Product Change Notice (PCN)

Subject: Bonding-wire change to Cu-wire and site addition of Back-Grinding, Assembly and Final Test for the RH850/F1 and D1 series.

Publication Date: 12/28/2021

Cu-wire product identification

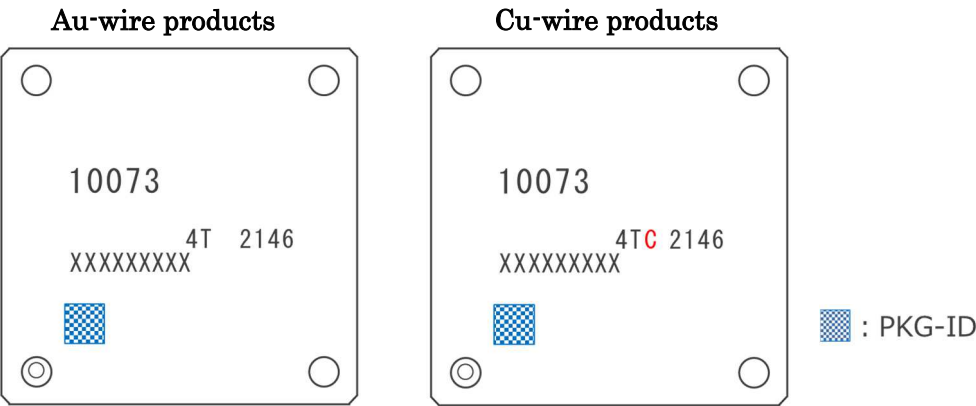
Product identification for Cu-wire products through mark print on each PKG

Mark example: ATJ-Kumamoto products for F1L-2M 176pin

Mark comparison between R7F7010073AFD#BA4(Au-wire) and R7F7010073AFD-**C**#BA4(Cu-wire)

“**C**” (The red character) is added in a part of the mark for the laser mark of Cu-wire products

Label comparison between R7F7010073AFD#BA4(Au-wire) and R7F7010073AFD-**C**#BA4(Cu-wire)

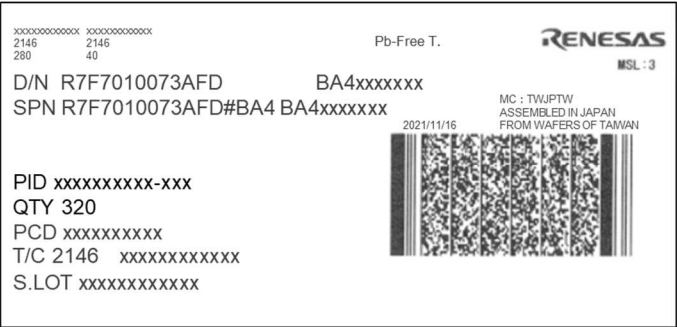
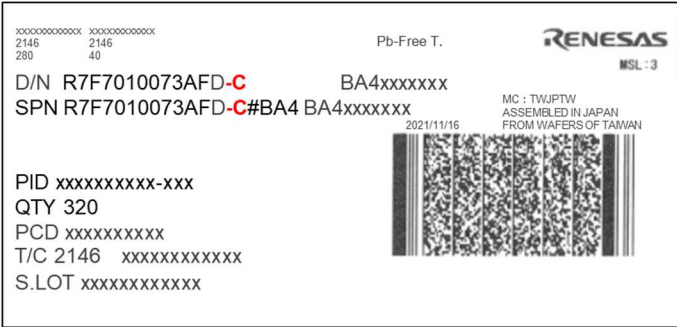
Product identification for Cu-wire products through label print

Label example: ATJ-Kumamoto products for F1L-2M 176pin

Label image for Au-wire products

Label image for Cu-wire products

The red characters are different.

RH850/F1L, F1M, F1H, F1K, D1L1 and D1L2 series

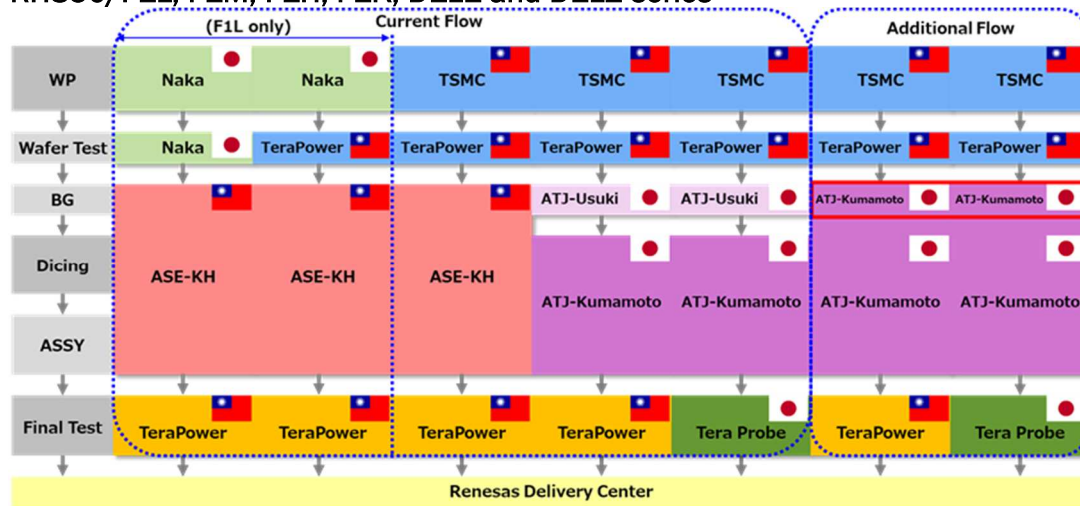
Additional sites

RH850/D1S1-V2 series

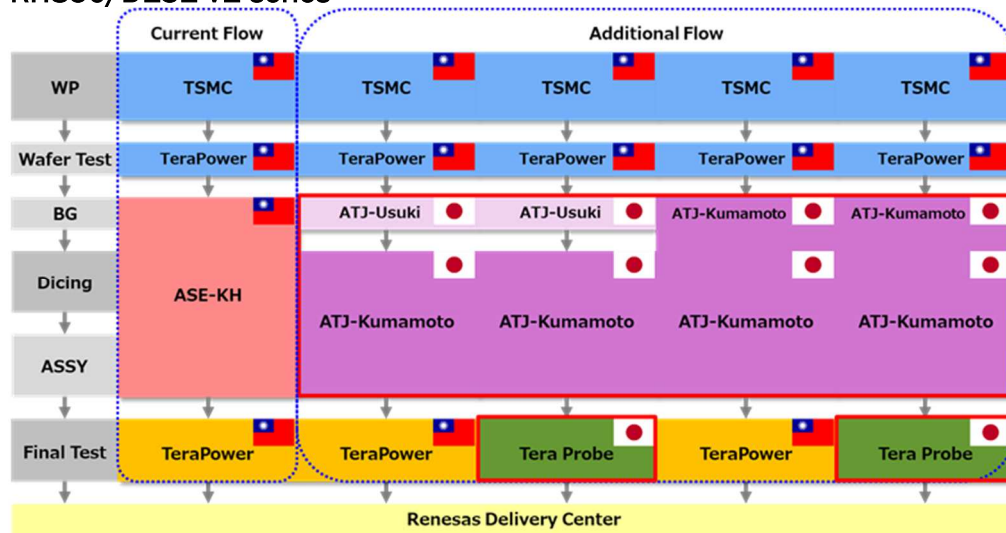
Au-wire(Before change)	Cu-wire(After change)	Remarks
Production sites	Wafer process	w/o change		Refer to "Production Flow"
	Wafer Test	w/o change		
	Back Grinding	ATJ-Kumamoto/ATJ-Usuki addition		
	Assembly	ATJ-Kumamoto addition		
	Final Test	TPJ addition *1		
Materials	PAD-opening(μ m)	w/o change		
	Wire-bonding materials	Au-wire	Cu-wire	*2
	Mold-resin materials	Mold-resin for Au-wire	Mold-resin for Cu-wire	
	Die-attach materials	ASE-KH standard materials	ASE-KH/ATJ-Kumamoto standard materials

RH850/F1KM series

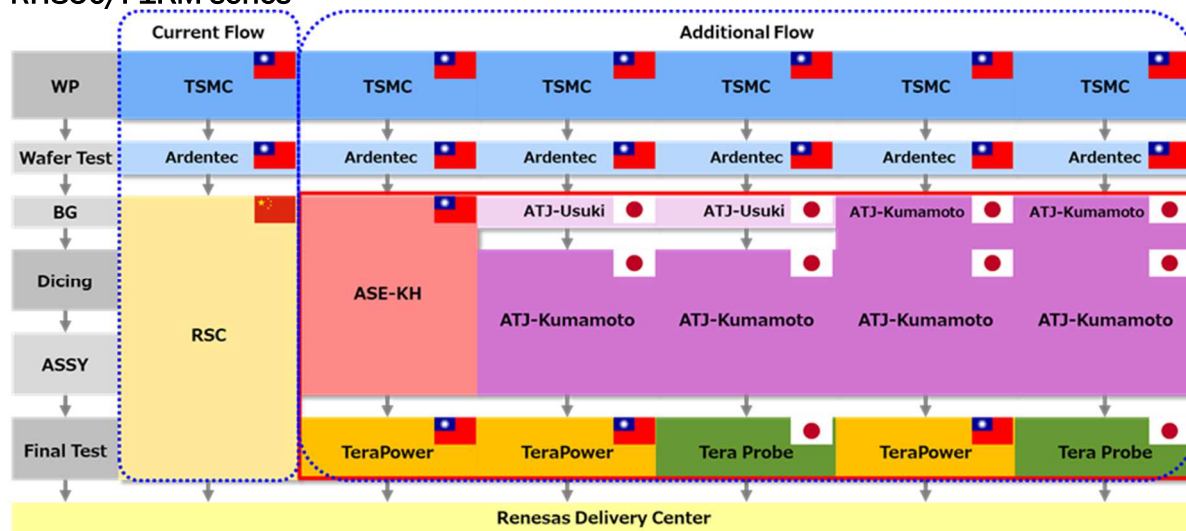
Cu-wire(Before change)	Cu-wire(After change)	Remarks
Production sites	Wafer process	w/o change		Refer to "Production Flow"
	Wafer Test	w/o change		
	Back Grinding	ATJ-Kumamoto/ATJ-Usuki addition		
	Assembly	ASE-KH/ATJ-Kumamoto addition		
	Final Test	ASE-KH/TPJ addition *1		
Materials	PAD-opening(μ m)	w/o change		
	Wire-bonding materials	w/o change		
	Mold-resin materials	RSC standard materials	ASE-KH/ATJ-Kumamoto standard materials	
	Die-attach materials	RSC standard materials	ASE-KH/ATJ-Kumamoto standard materials
